CONTRACT NO. 1799

SOLIDS THICKENING AND DEWATERING IMPROVEMENTS

ADDENDUM NO. 2

CONTRACT NO. 1799
SOLIDS THICKENING AND DEWATERING IMPROVEMENTS PROJECT

3.1 On Sheet MD-002, **ADD** the following DETAIL G to the sheet after DETAIL F:

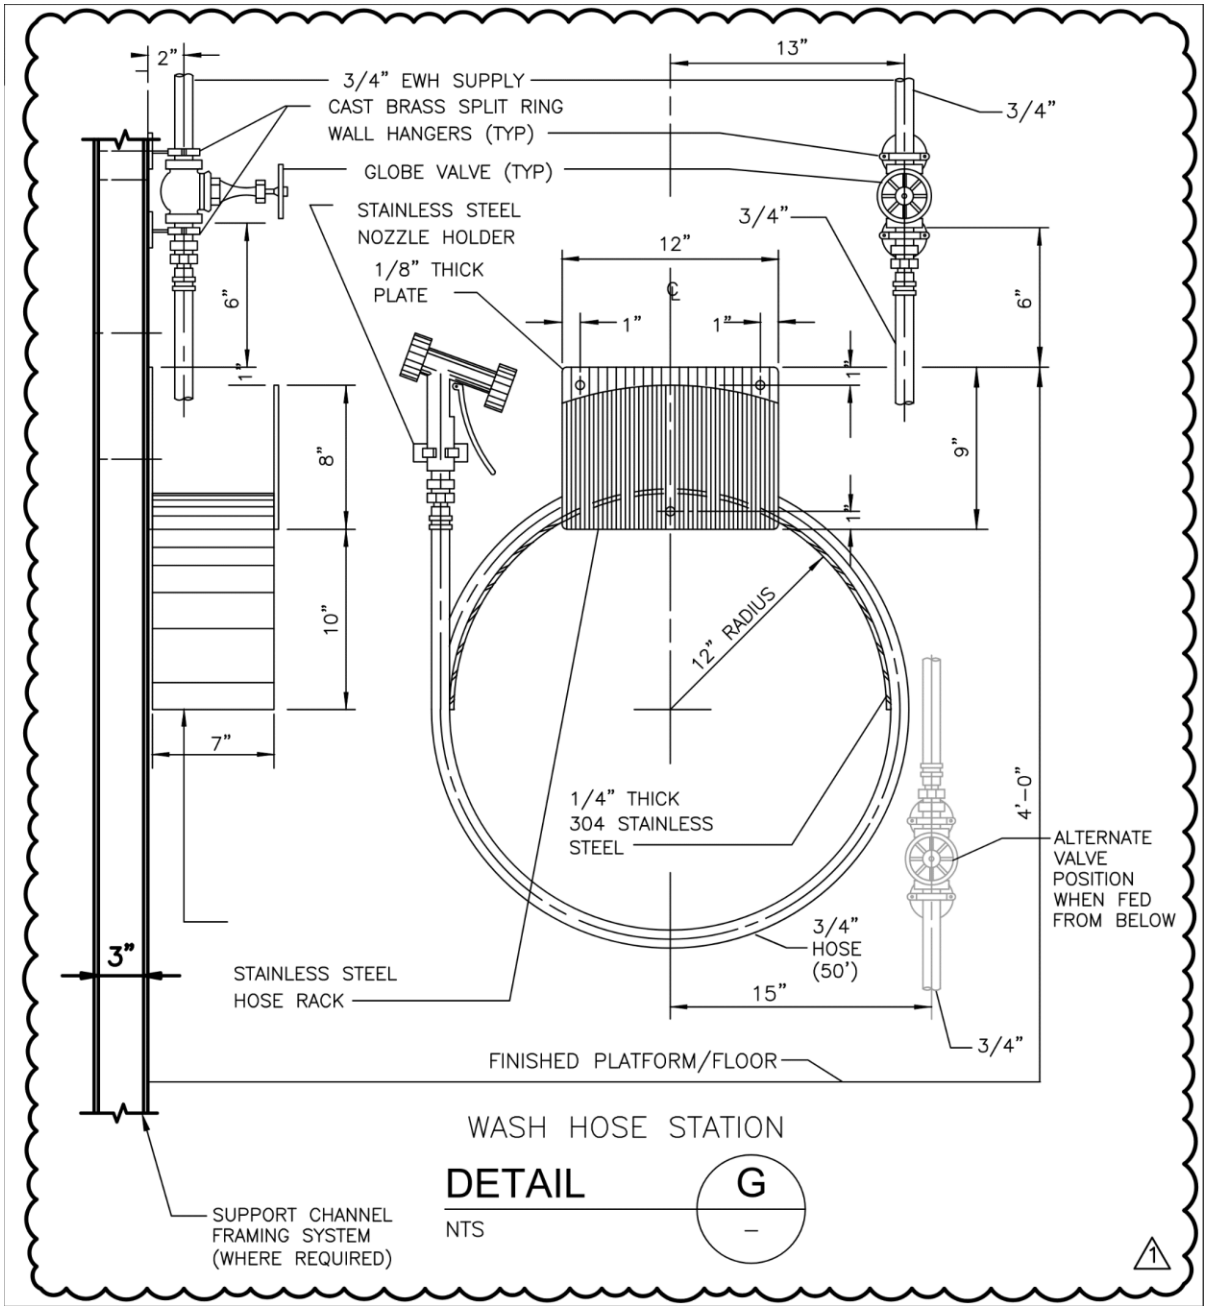
Q2: In reference to plan sheet 400-M-122, notes 1.5" wash hose station [Typ. 2] per Det. 7/MD-002, but there is no Detail 7 on MD-002. Please provide 1.5" wash hose station detail by addendum.
A2: See Changes to the Drawings in this Addendum No. 2.

3.8 On Sheet 400-M-122, **DELETE** "1-1/2" WASH HOSE STATION (TYP 2)" with symbol "7 / MD-002" associated with the 1.5" connection to the 4" EWH tee and **REPLACE** with "1-1/2 WASH HOSE STATION W/ 1-1/2" GST PIPE, BLV & QUICK CONNECT (TYP of 4) (SIM TO DETAIL F/MD-002)."

3.5 On Sheet 520-M-104, **UPDATE** per modifications shown below:

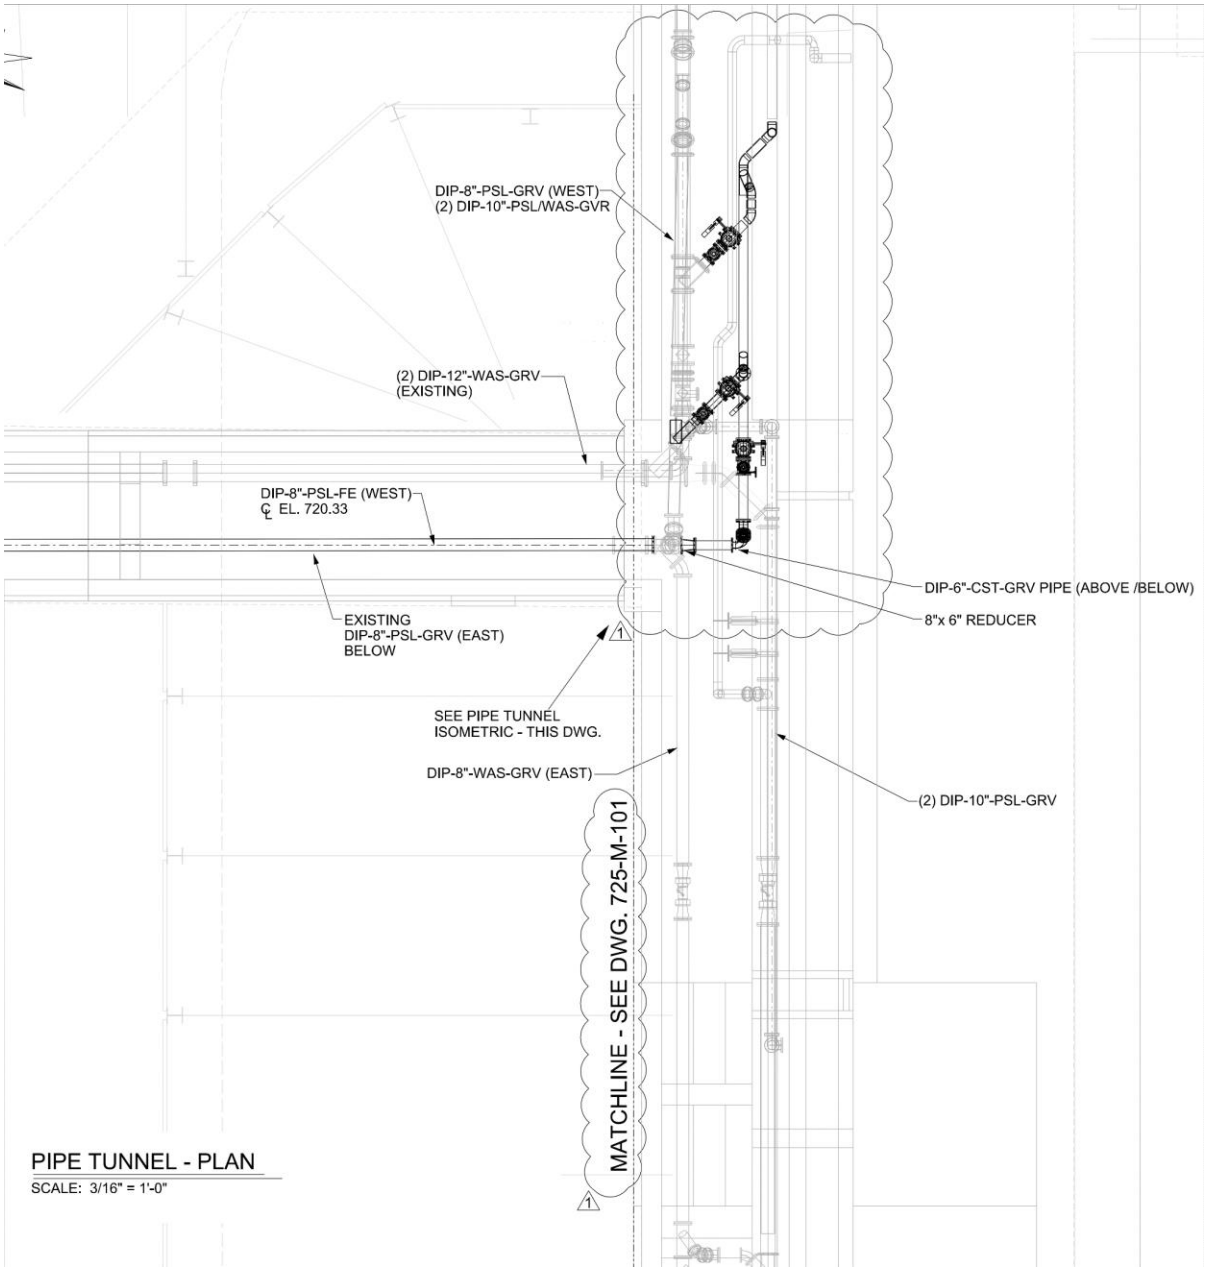
Q4: In reference to plan sheet 520-M-104, there is missing & contradictory info on this dwg. Perhaps the line weights are incorrect and most of the pipe shown as bold is actually existing piping that remains unchanged. A few sections or elevation views are needed in order to complete take-off here. See attached pic w/ several highlighted questions.
A4: See Changes to the Drawings in this Addendum No. 2.

Q6: Drawing 520-M-104 shows the piping going to the west tunnel. I see on drawing 725-M-101 marks the valves but the piping at the intersections very confusing. The iso on 520-M-104 does not help. Can you please clarify?
A6: See Changes to the Drawings in this Addendum No. 2.

3.6 On Sheet 725-M-101, **UPDATE** per modifications shown below:

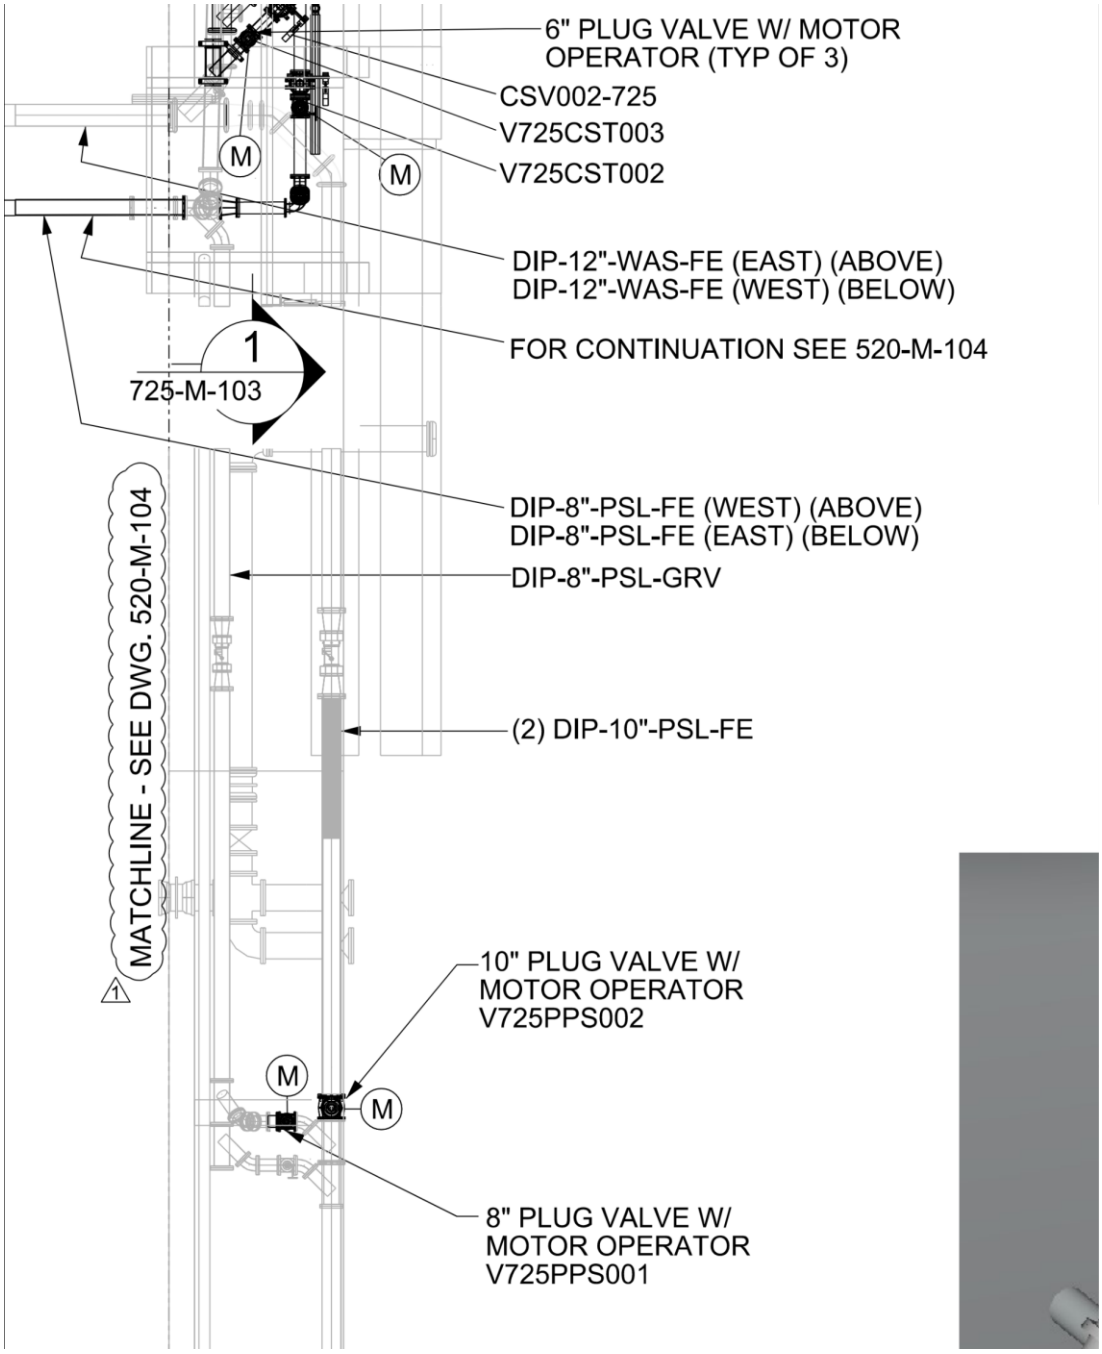
Q5: In reference to section 1 on plan sheet 725-M-103, the DIP.GL-06"-CST-GRV doesn't seem to match the "Green" DIP.GL-06"-CST-GRV shown on ISOs at DETAILs A & C on 725-M-101. Please clarify which SEC or DET is correct for components needed to complete the new DIP.GL-06"-CST-GRV lines by addendum.
A5: See Changes to the Drawings in this Addendum No. 2.

MEZZANINE DUCTWORK NEW WORK

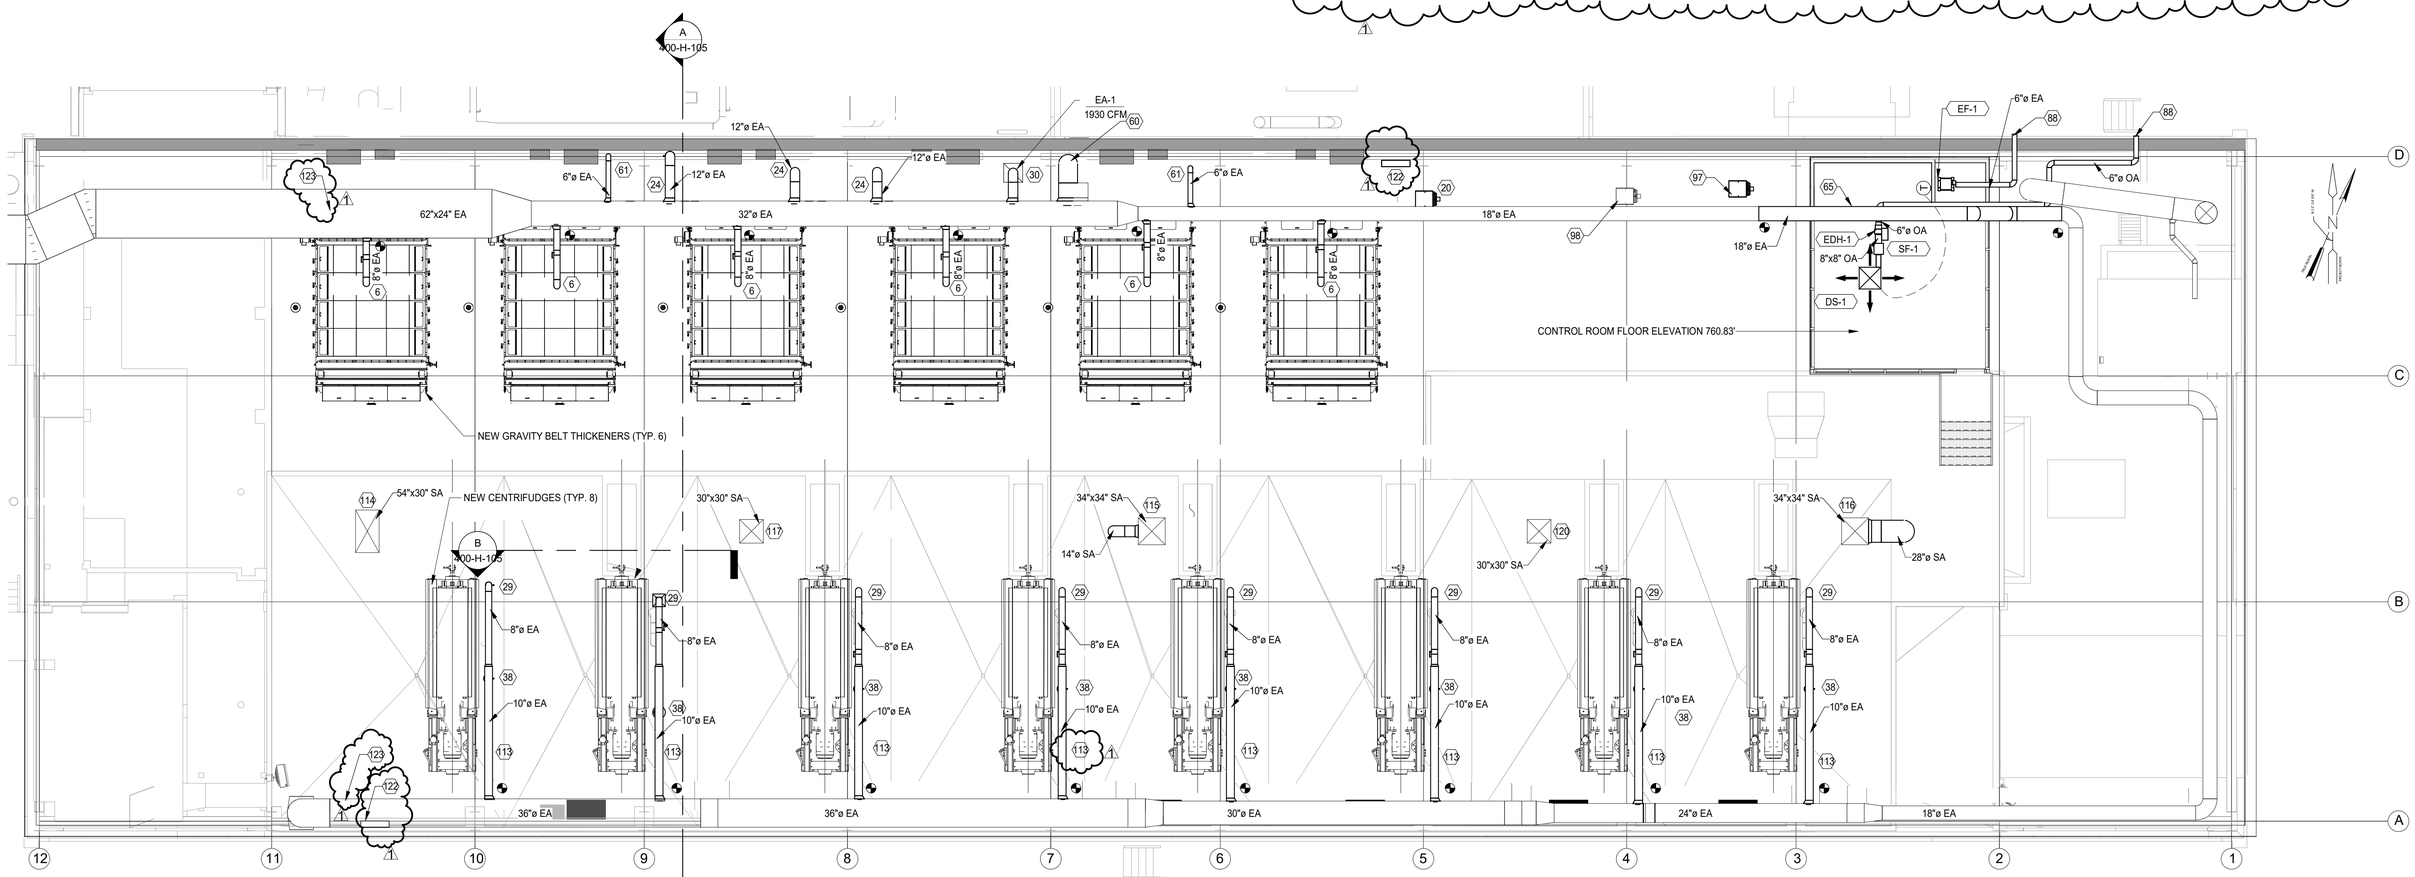
113. PROVIDE AIR FLOW MONITORING SENSOR. SENSOR TO PROVIDE AN ALARM INCASE THE AIRFLOW THROUGH THE DROP FALLS BELOW 468 CFM (ADJ.). PROVIDE AUDIBLE AND VISUAL ALARMS IN THE PROCESS ROOM. 1

123. PROVIDE FLOW SWITCH IN EXISTING DUCTWORK AT THE LOCATION INDICATED TO SERVE EXHAUST IN THE SPACE. FLOW SWITCHES SHALL BE 24V DC AND POWERED FROM TEMPERATURE CONTROLS PANEL. MECHANICAL CONTRACTOR SHALL BE RESPONSIBLE FOR PROVIDING 24V TRANSFORMER AND PROVIDING ANY WIRING DOWNSTREAM OF 24V TRANSFORMER. ELECTRICAL CONTRACTOR SHALL BE RESPONSIBLE FOR PROVIDING WIRING UPSTREAM OF 24V TRANSFORMER. REFER TO SPECIFICATION SECTION 230923.14 FOR ADDITIONAL INFORMATION. PROVIDE A SINGLE OUTPUT FOR GENERAL CONTRACTOR FOR GAS MONITORING PANELS. 1

400-ET-121
DEWATERING BUILDING
ELECTRICAL - MEZZANINE FLOOR PLAN

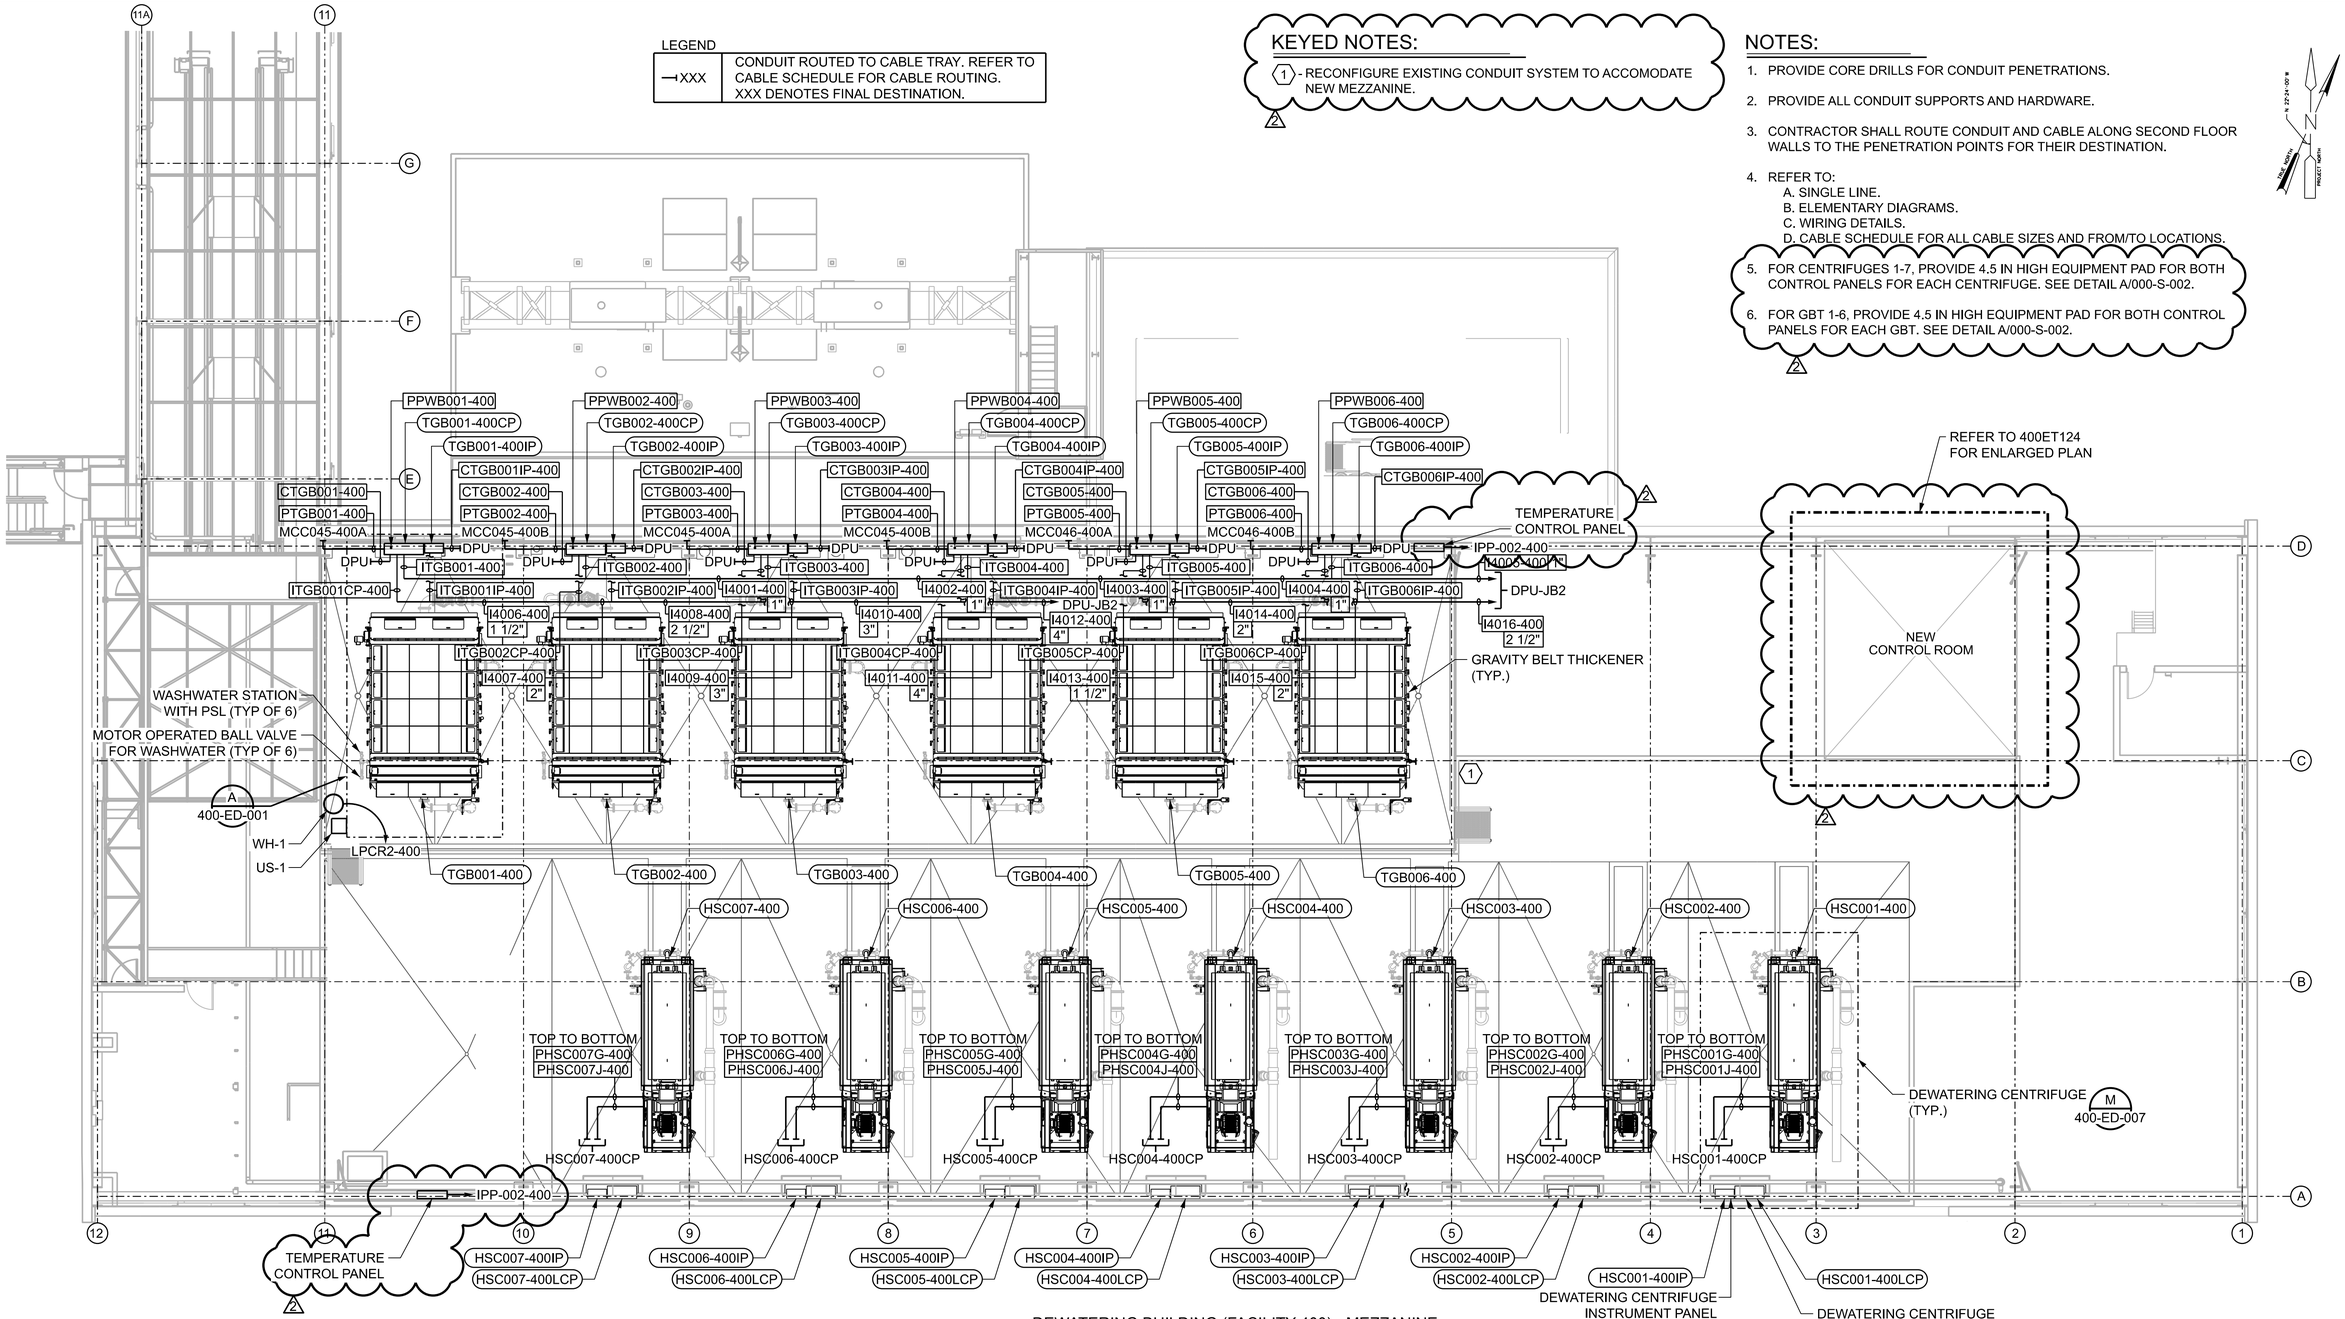
Q27: Ref. 400-ET-121 note 1
Please provide catalog no. for the 2x4 fixture.
Please reference what the indicated us-1 symbol is and power requirements.
A27: See Changes to the Drawings in this Addendum No. 2.
US-1 does not have power requirements.
